Staff Report

To: Salt Lake City Historic Landmark Commission
From: Anthony Riederer
801-535-7625 or anthony.riederer@slcgov.com
Date: April 7, 2016
Re: PLNHLC2015-00967 – New Construction in a Historic District
PLNHLC2016-00176 – Demolition of Non-Contributing Structures

NEW CONSTRUCTION AND DEMOLITION OF NON-CONTRIBUTING STRUCTURES

PROPERTY ADDRESS: Approximately 740 South 700 East
PARCEL ID: 16-08-105-016 and 16-08-105-015
HISTORIC DISTRICT: Central City Local Historic District
ZONING DISTRICT: RMF-30 (Residential Multi-Family, Low Density)
MASTER PLAN: Central Community Master Plan

NORTH ELEVATION

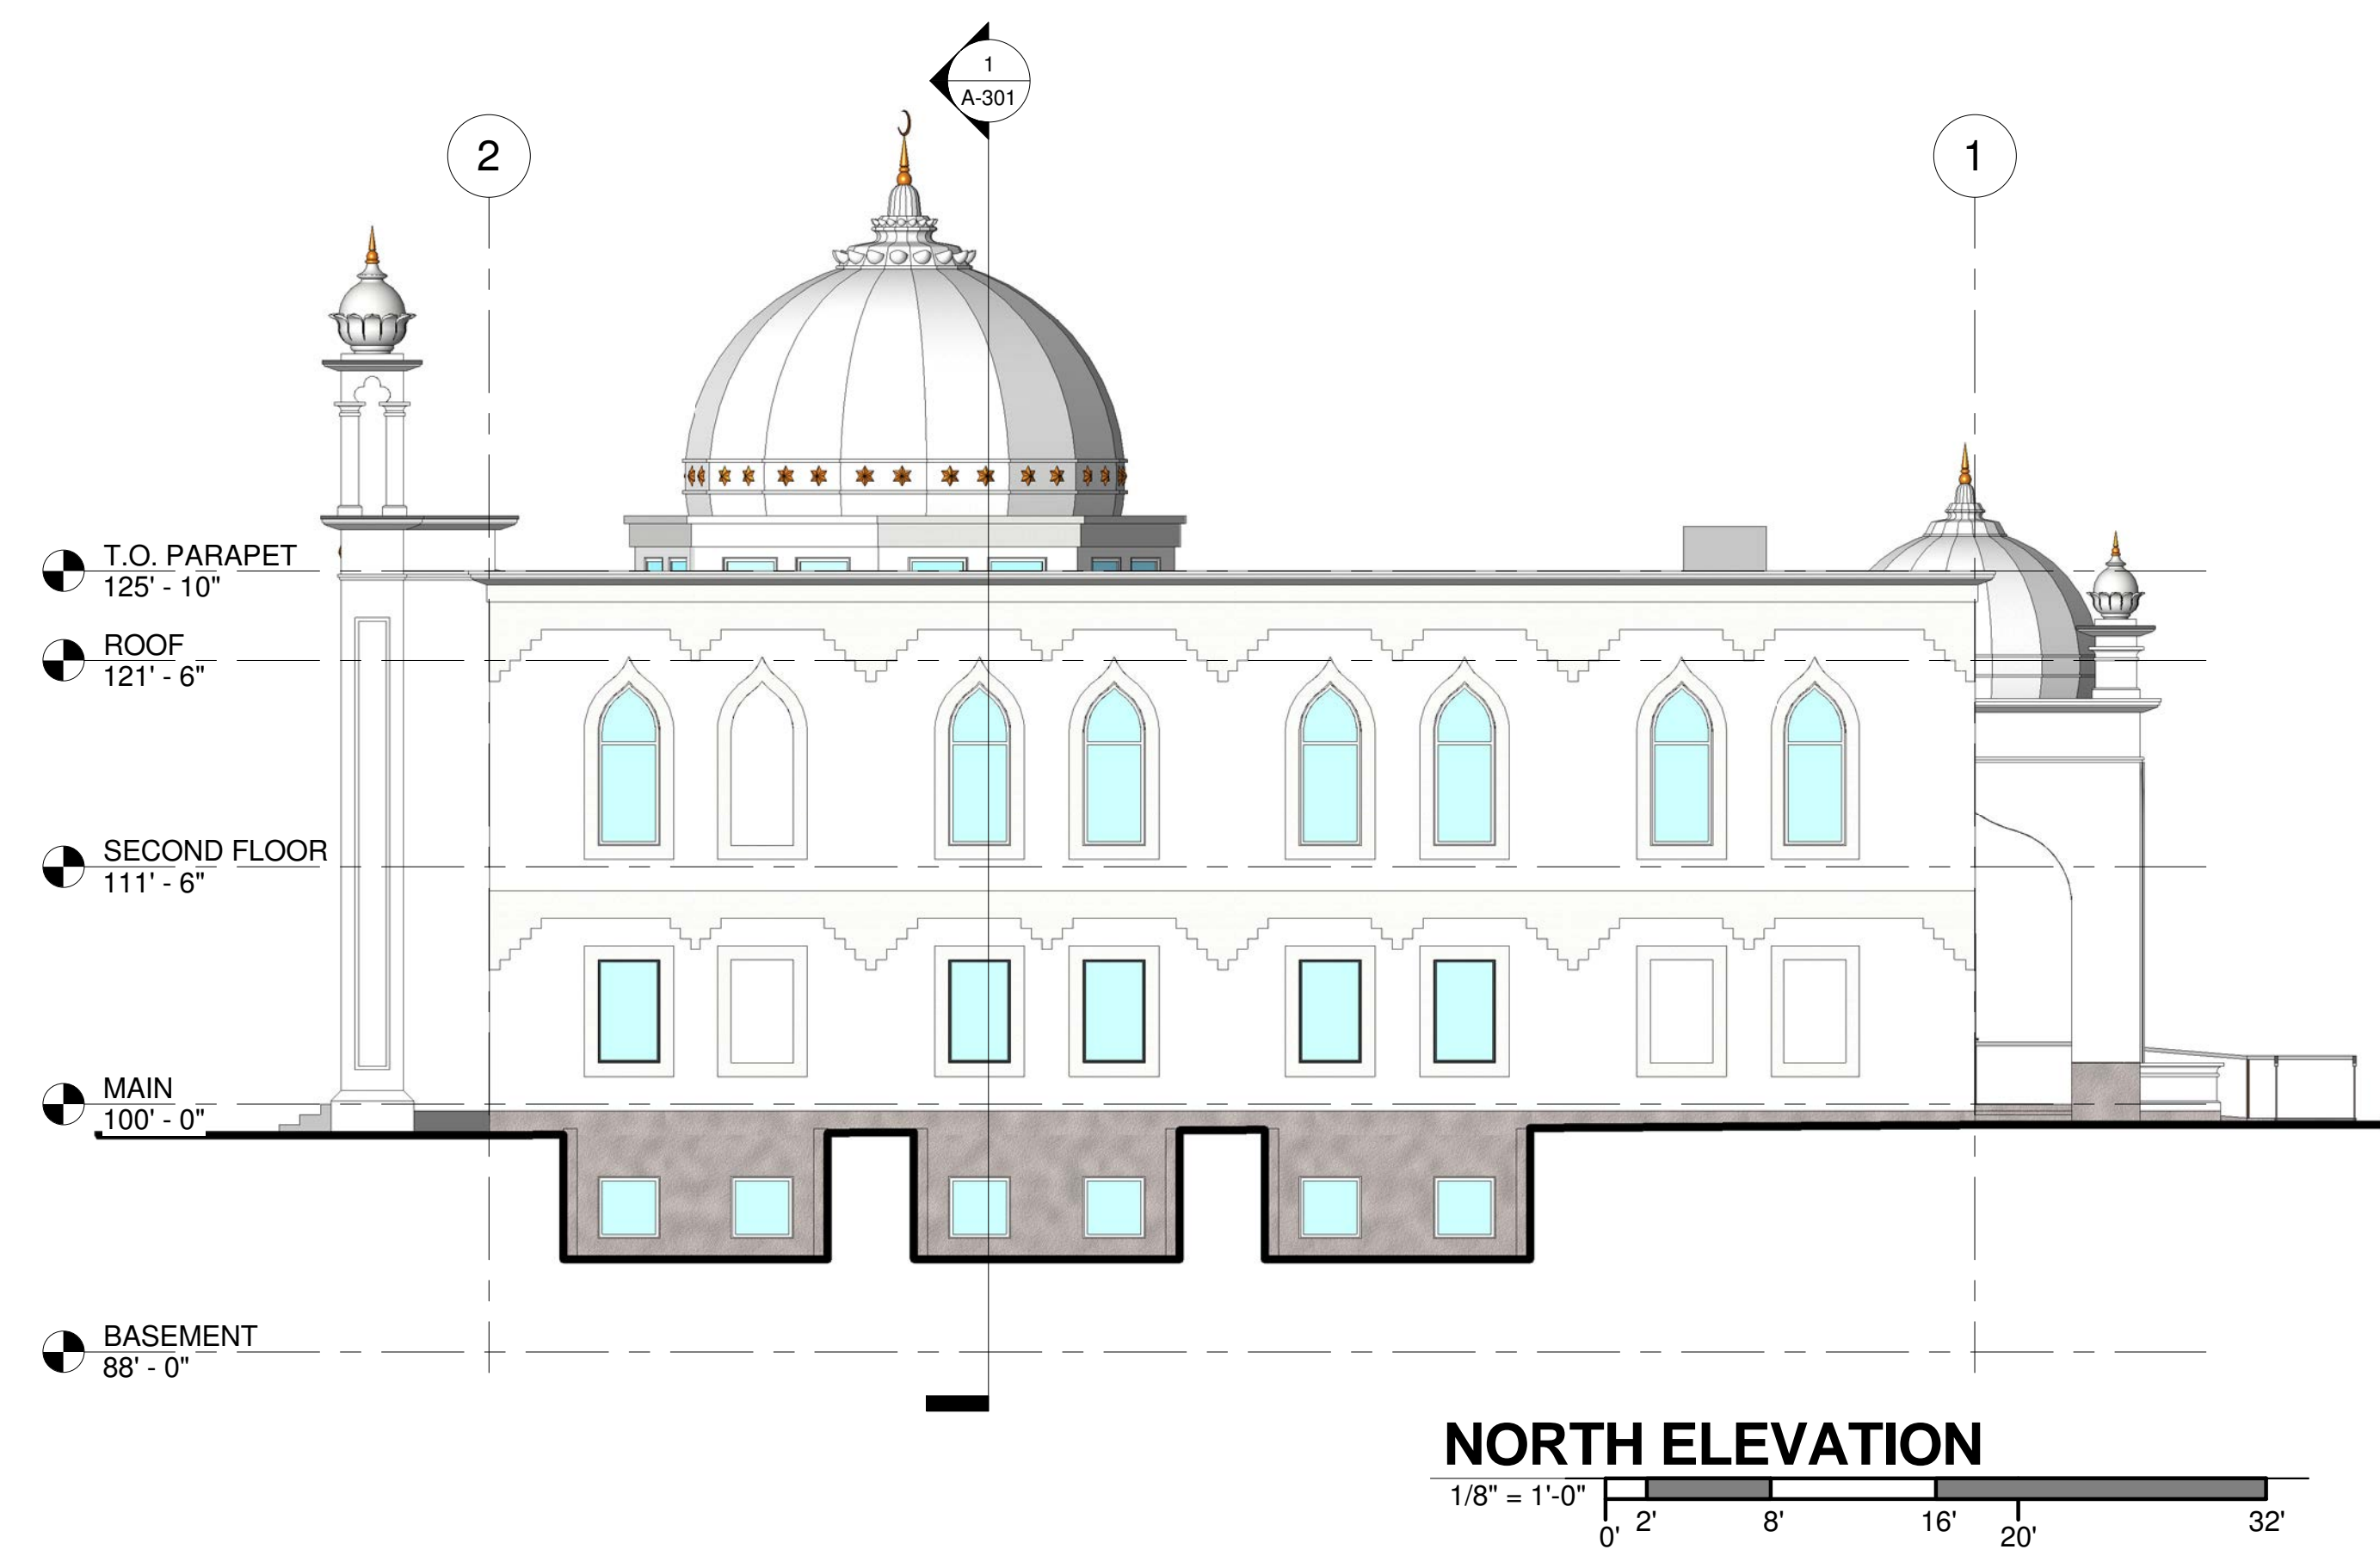
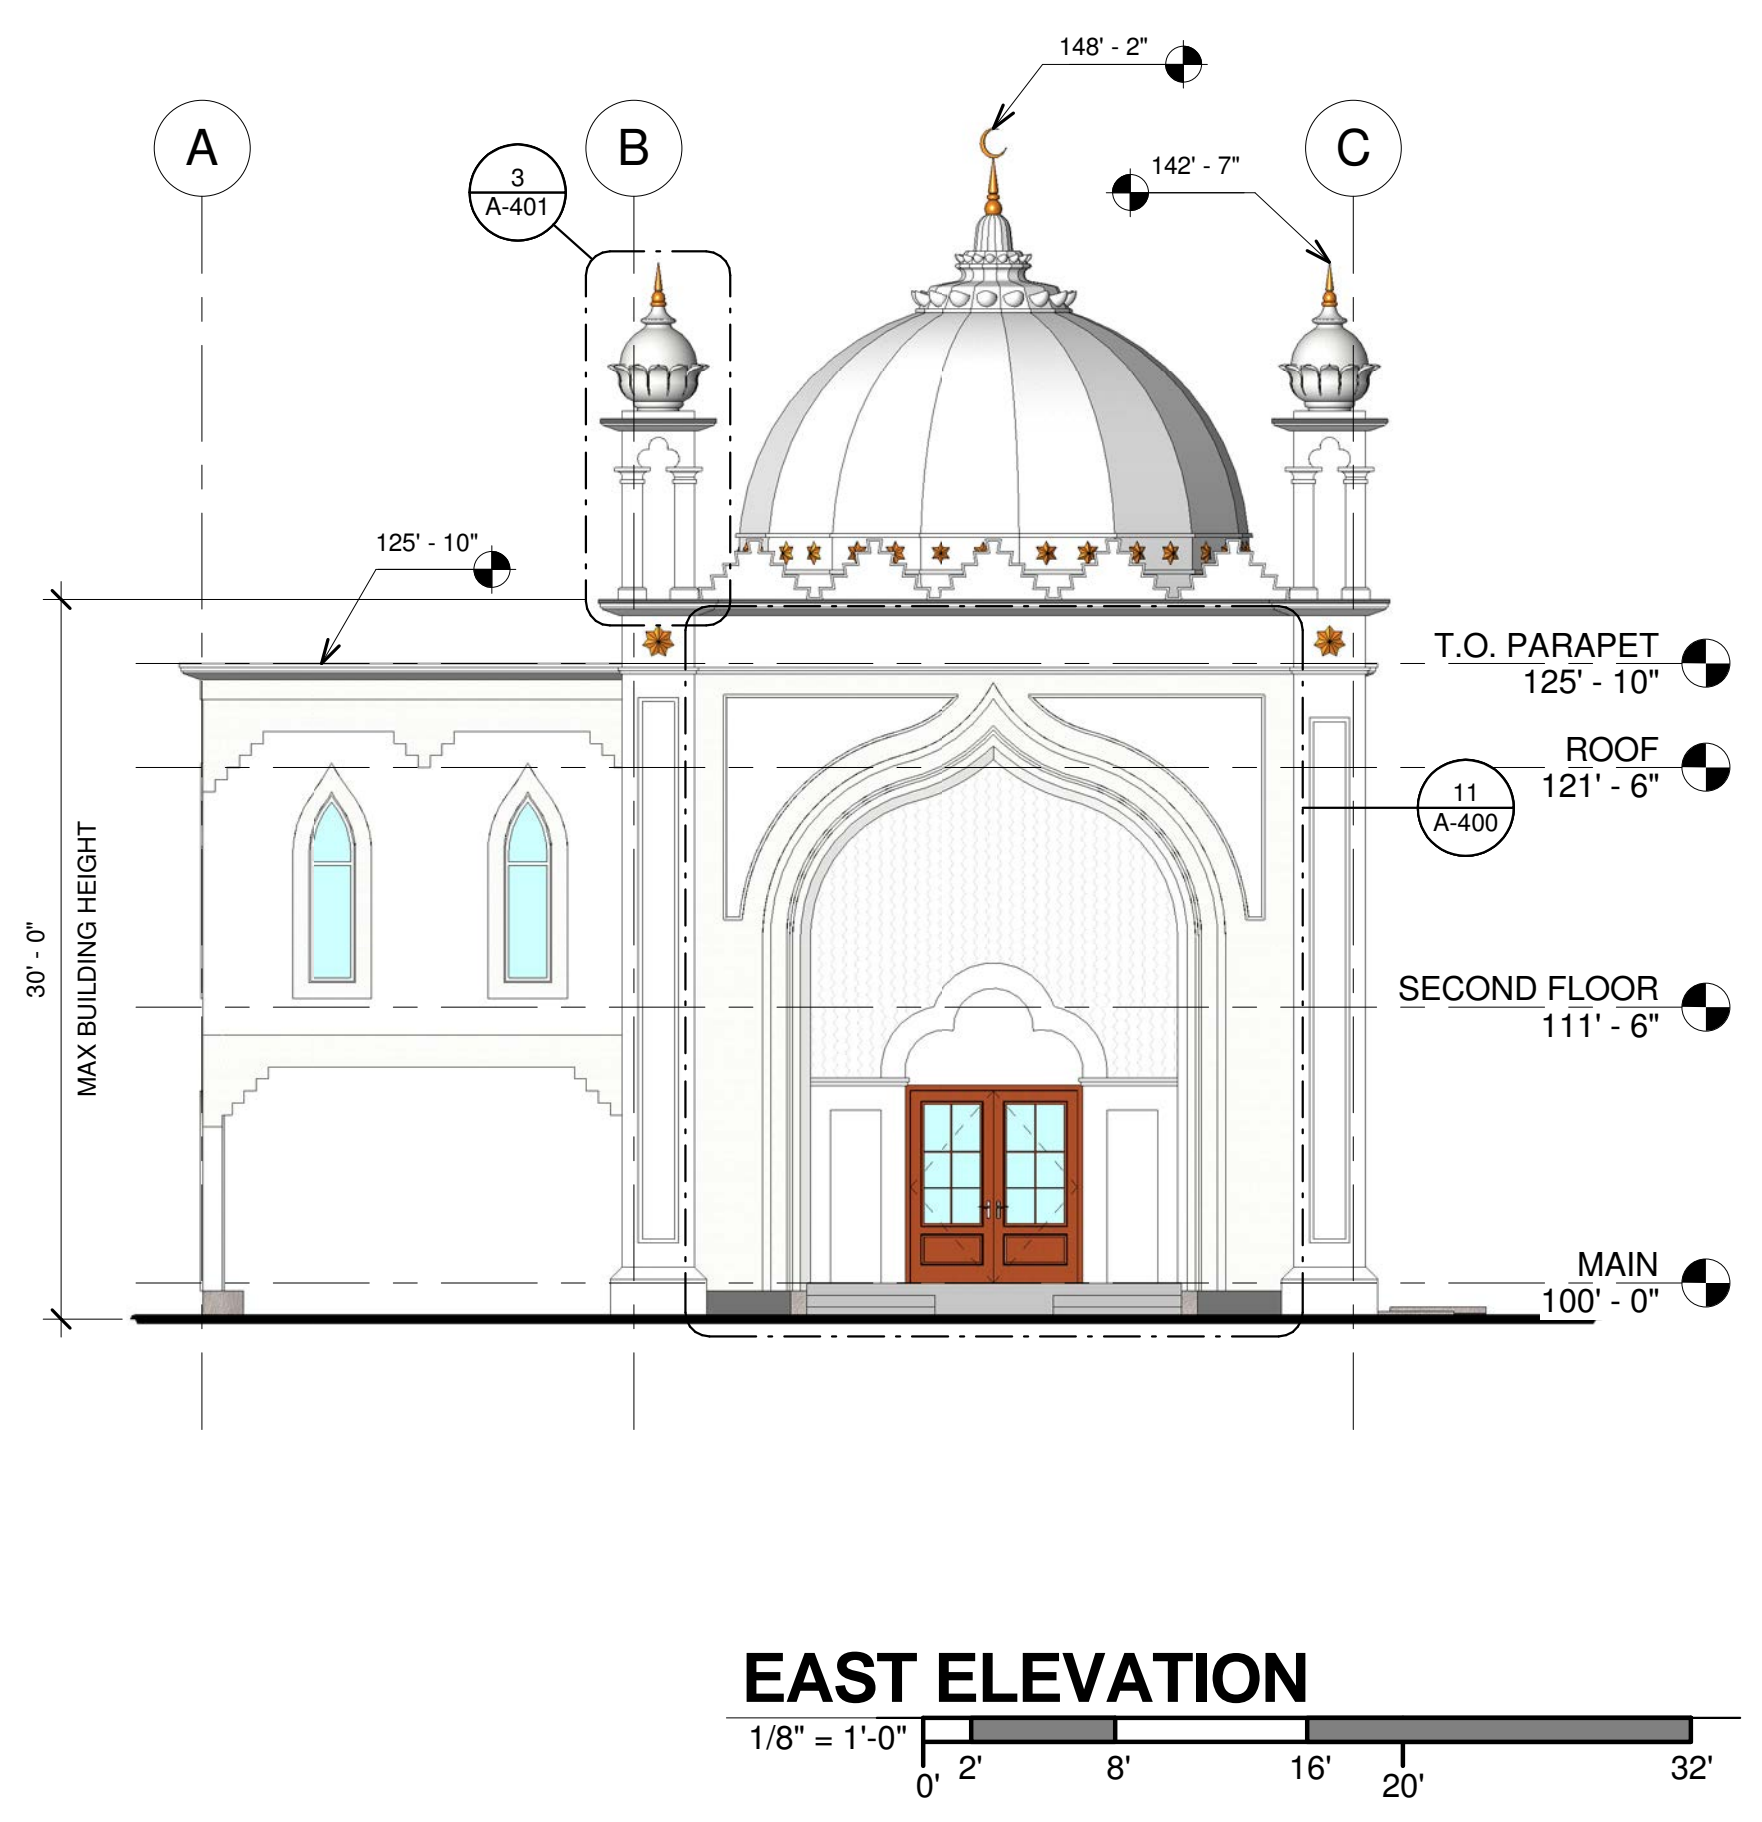
Issue 1: Depth and Dimensionality of Window Reveals

Frequently, on historic buildings, windows are somewhat recessed into a façade allowing shadows to help create dimensionality along the façade. There are a number of windows on each façade of the building and, given its scale, many will be particularly visible from the public way. Although care has been taken in the proposed design to outline windows with differentiated and complimentary surrounds, they sit fairly close to the plane of the façade. This forestalls the possibility for the creating of shadows and hence the articulation common to other buildings in the district.

Issue 4: Façade Materials

Much of the exterior of the proposed building is intended to be composed of hard coat stucco. Though this is a material commonly found throughout the Central City district, the proposed design offers a significant amount of it in a single building.

- 1) Depths of window reveals are revised to provide improved façade articulation.
- 2) The site plan is revised to accord with project review comments received from Salt Lake City's Transportation Division.
- 3) The lots are consolidated into a single parcel.
- 4) The design complies with all applicable building and development codes.
- 5) Approval of final design details are delegated to staff for approval.
